**NSLPP MEETING HELD ON 01/05/24****Attachments:**

ADDRESS/WARD: Unit 9 and 9A, 50 Milson Road, Cremorne Point**APPLICATION NO:** DA353/23**PROPOSAL:** Consolidation of two units, alterations and additions including internal demolition and reconfiguration, landscaping and addition of pergola on existing roof terrace.**PLANS REF:**

OWNER: Robyn Mary Assunta Denholm**APPLICANT:** Robert Furey C/O Walter Barda Design**AUTHOR:** Report of Robin Tse, Senior Assessment Officer**DATE OF REPORT:** 22 April 2024**DATE LODGED:** 15 December 2023**RECOMMENDATION:** Approval

1 Roof Plan
1:100

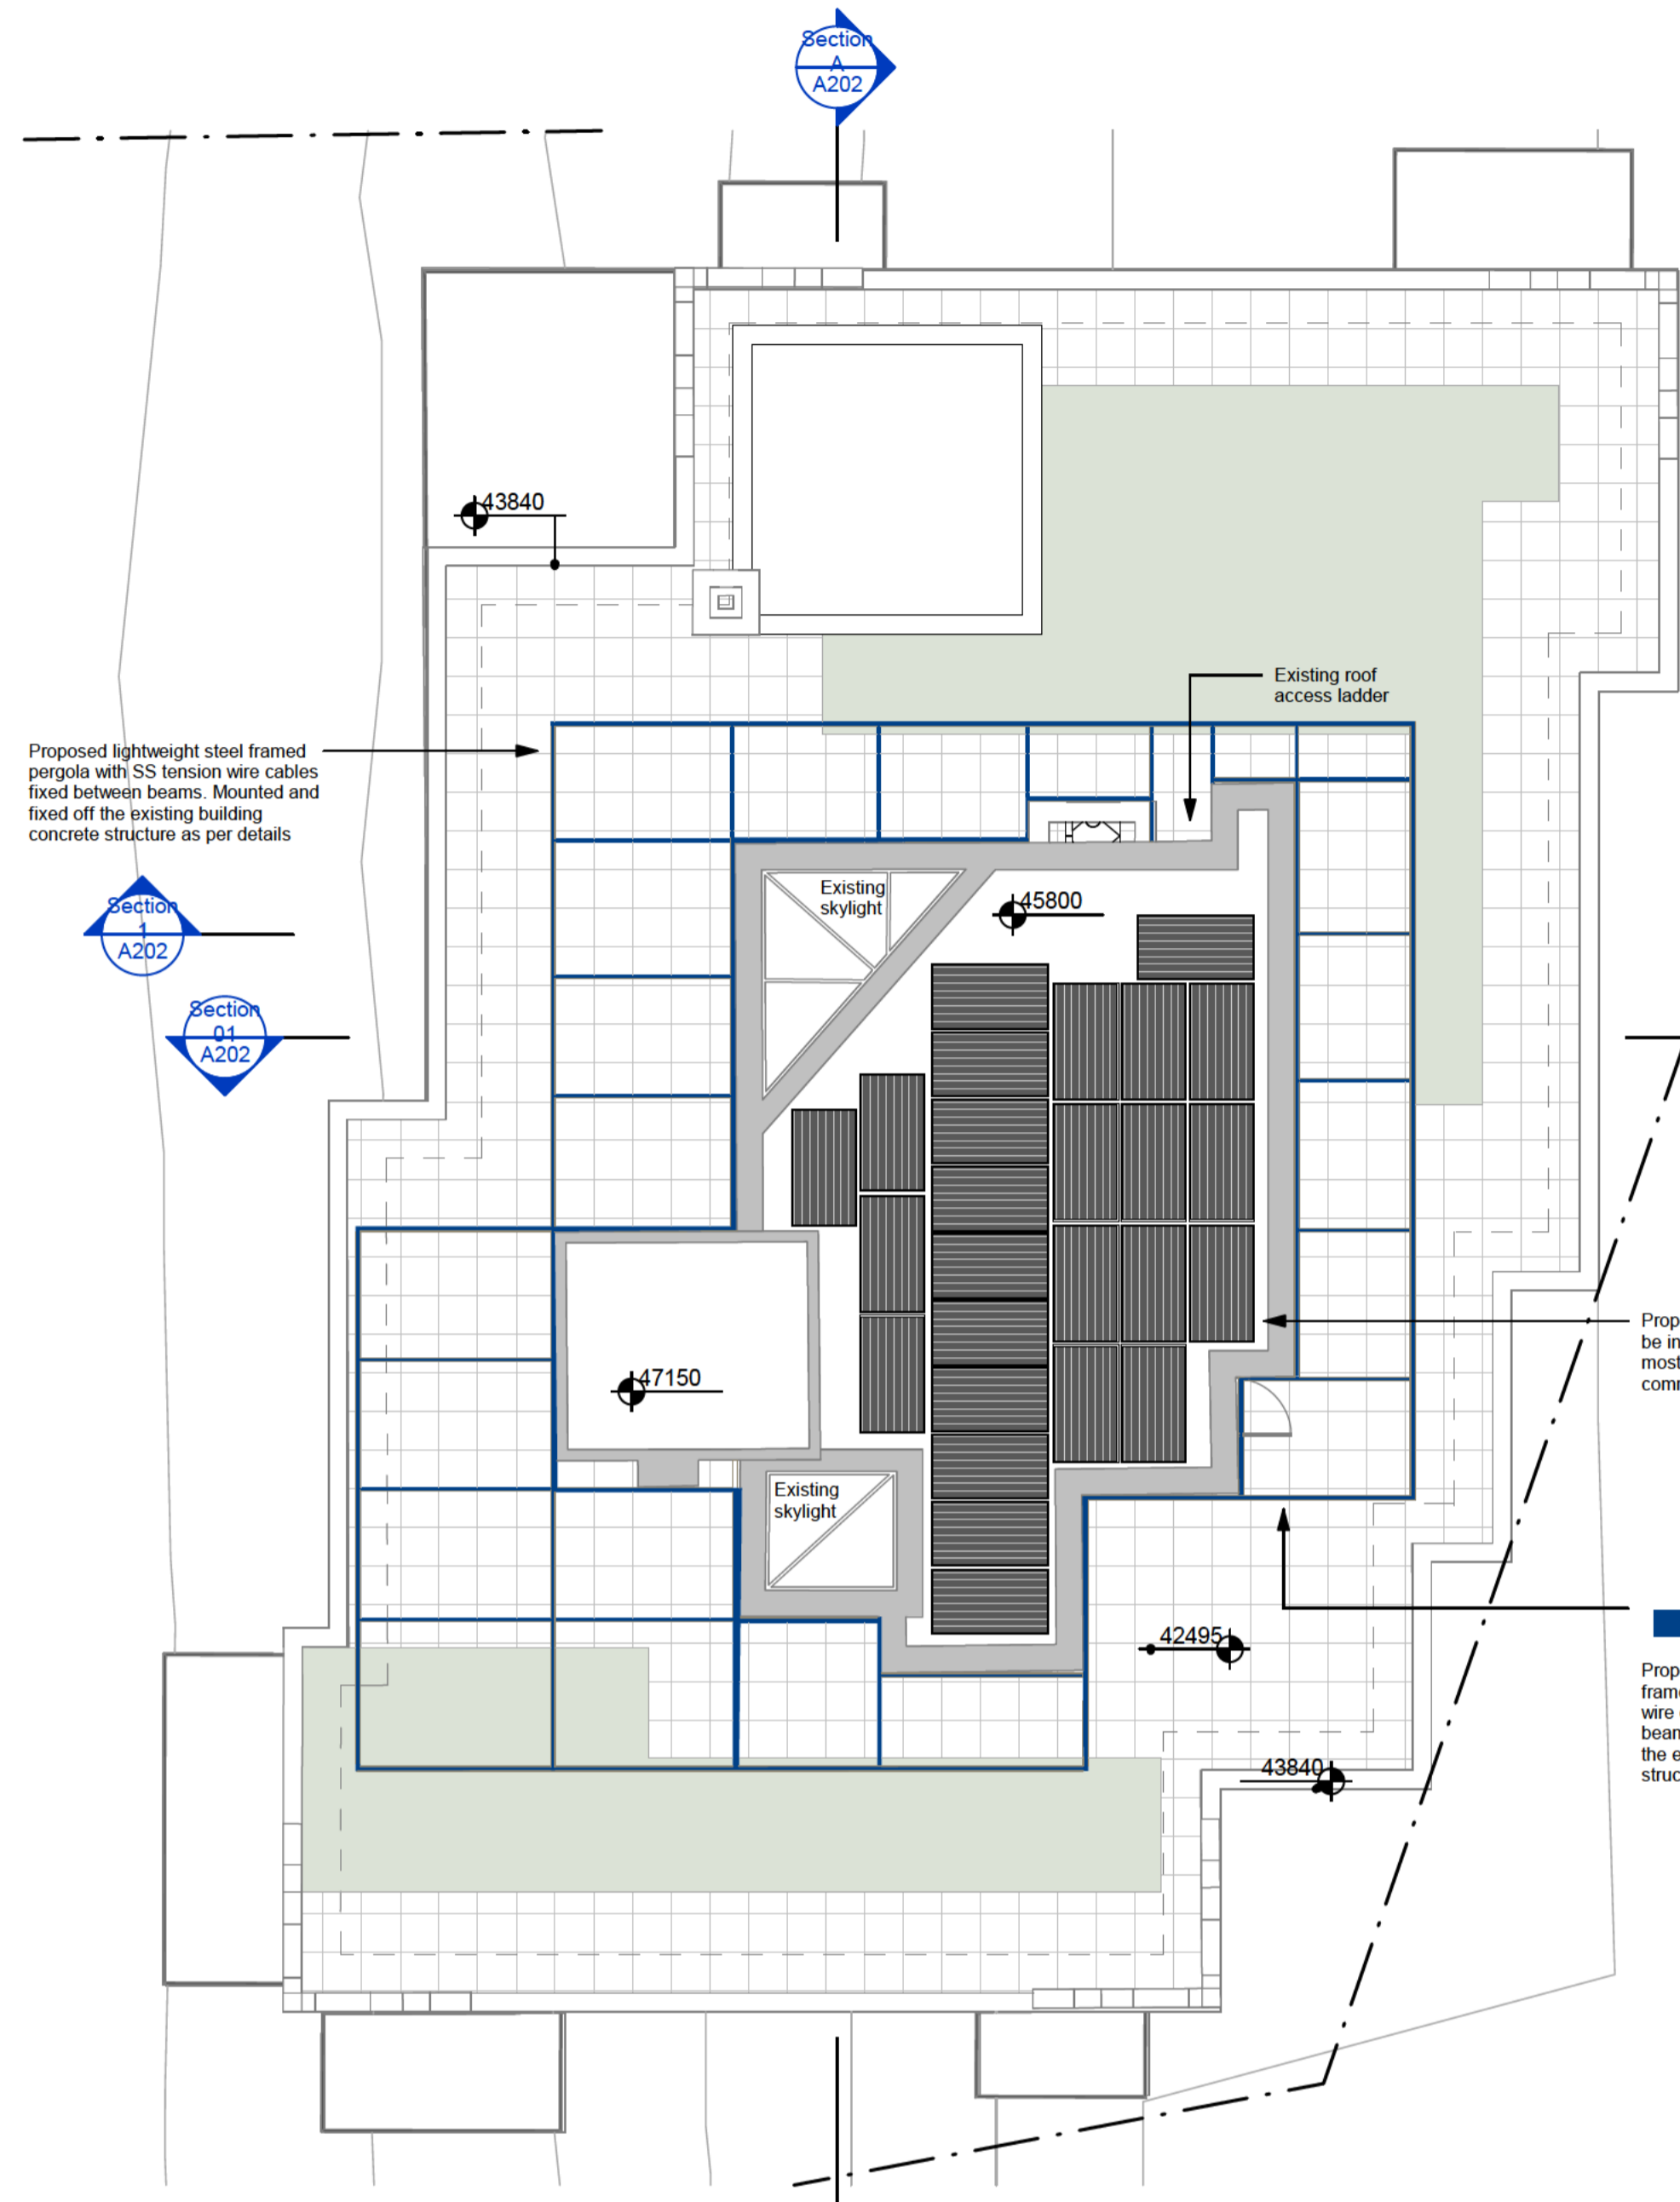
- C2. The following design modifications shall be applied to the proposed development:
- (a) The proposed pergola to the south of the southern building line of the roof level (Level 10) structure containing the conservatory/kitchen/bathroom shall be deleted and form no part of this consent to minimise any impacts on significant views as seen from the neighbouring properties; and
 - (b) The existing flagpole on top of the Level 10 structure shall be removed.
